UNITARY PLAN UPDATE REQUEST MEMORANDUM

SUBJECT **Plan Change 51 Drury 2 Precinct to the Auckland Unitary Plan (AUP) Operative in part (15 November 2016)**

| Reason for update – Plan Change 51: Drury 2 Precinct to be made operative in part | |
| Section | South – I448 Drury 2 Precinct |

PC 51 - PRECINCT PLAN

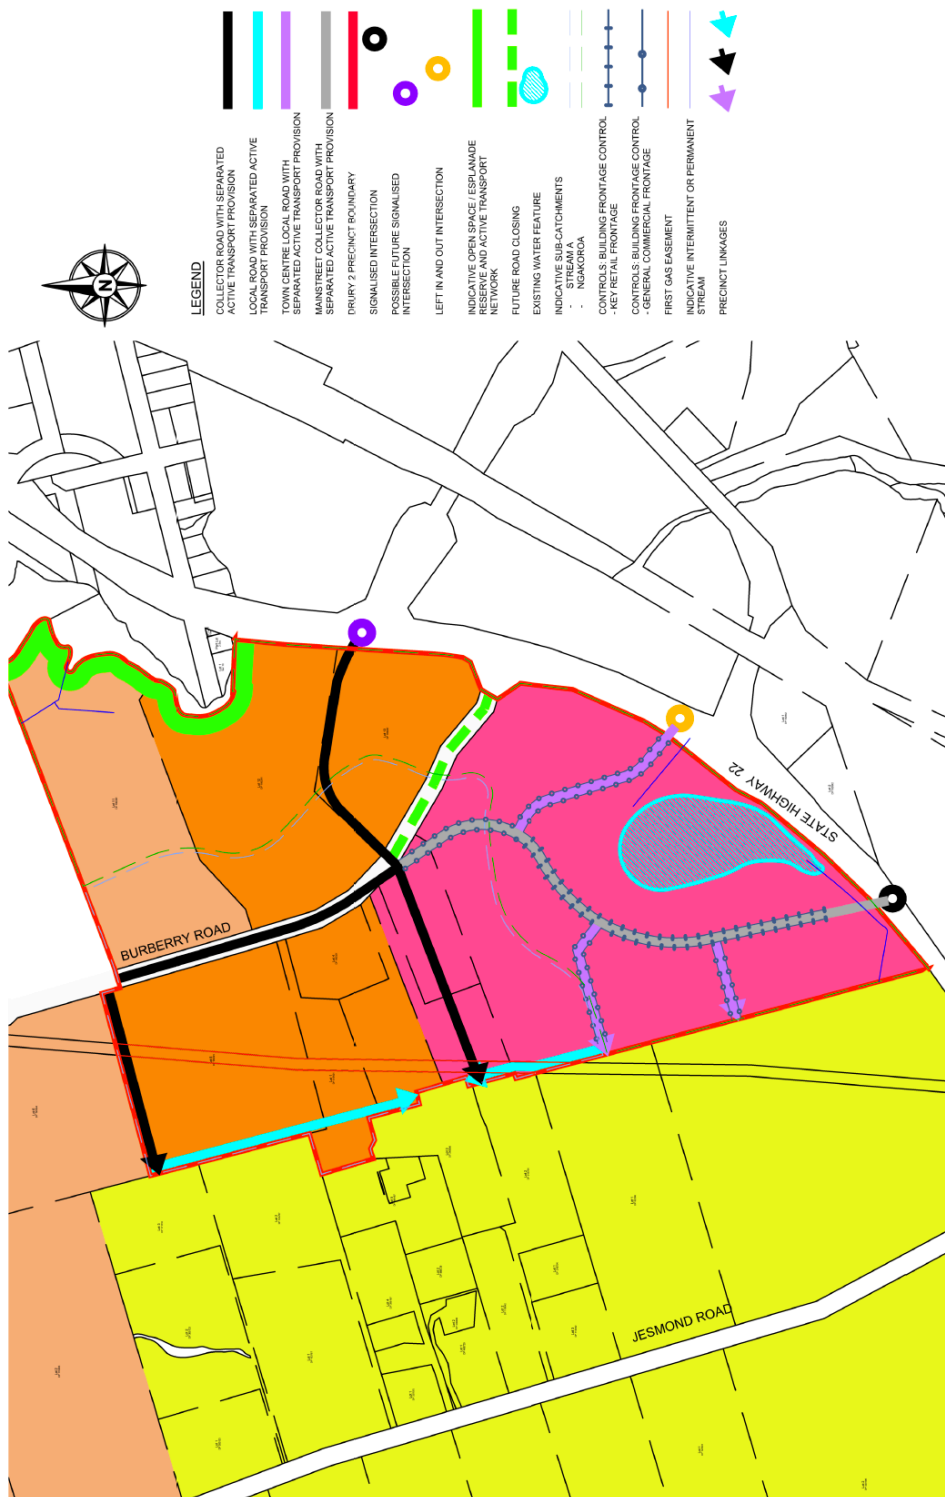
| Reason for update – Plan Change 51: Drury 2 Precinct to be made operative in part | |
|--|--|
| Changes to diagrams | New precinct plan – ‘Drury 2 Precinct Plan’ This goes with the new precinct text referred to above. Refer to the attachment for the make operative report for details. |

Drury 2 Precinct

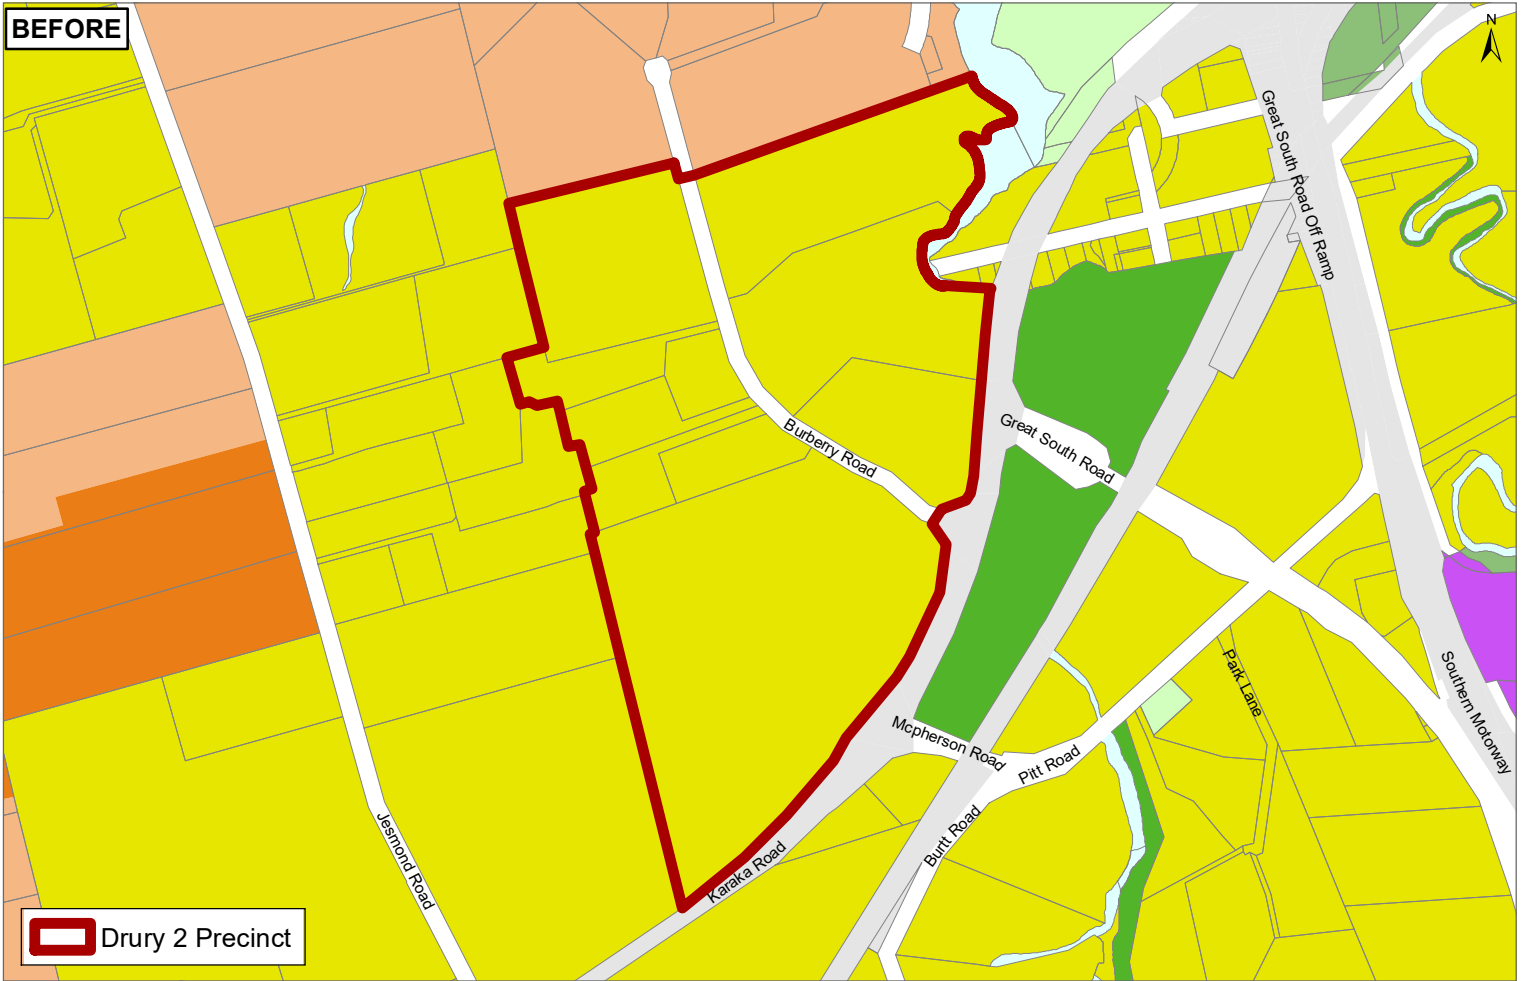
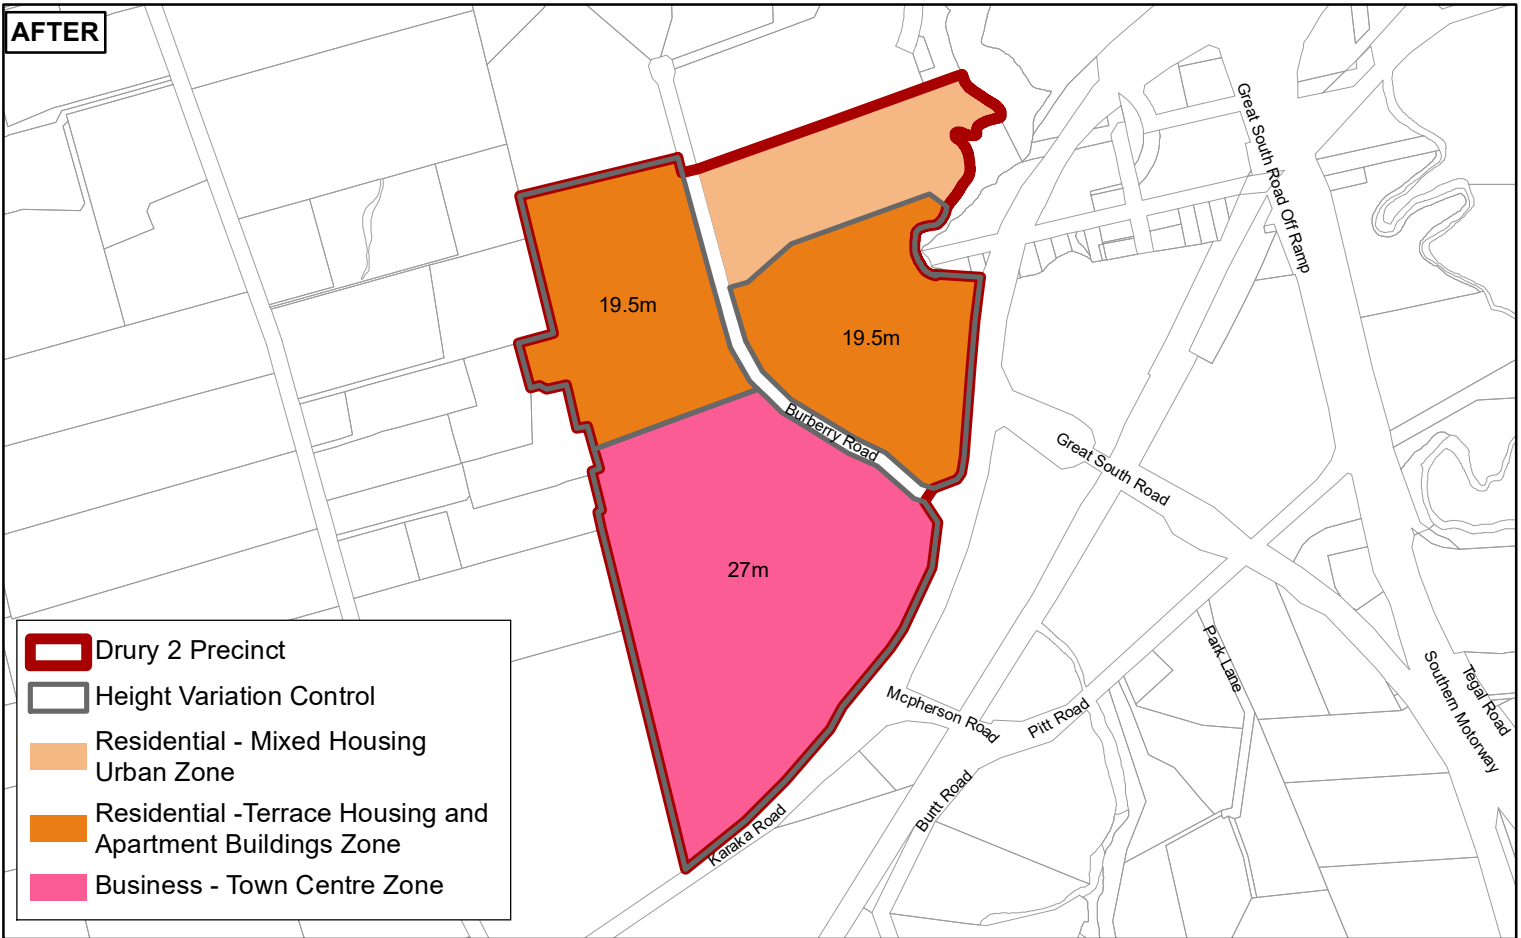
| Reason for update – Plan Change 51: Drury 2 Precinct to be made operative in part | |
|--|--|
| Changes to spatial data | Zoning change to the AUP maps: Replace Future Urban zone with; Business – Town Centre Zone, Residential – Terrace Housing and Apartment Buildings Zone and Residential – Mixed Housing Urban Zone. Insert a new Height Variation Control in the AUP maps Insert a new precinct boundary in the AUP maps All as per the attachment for the make operative report. |
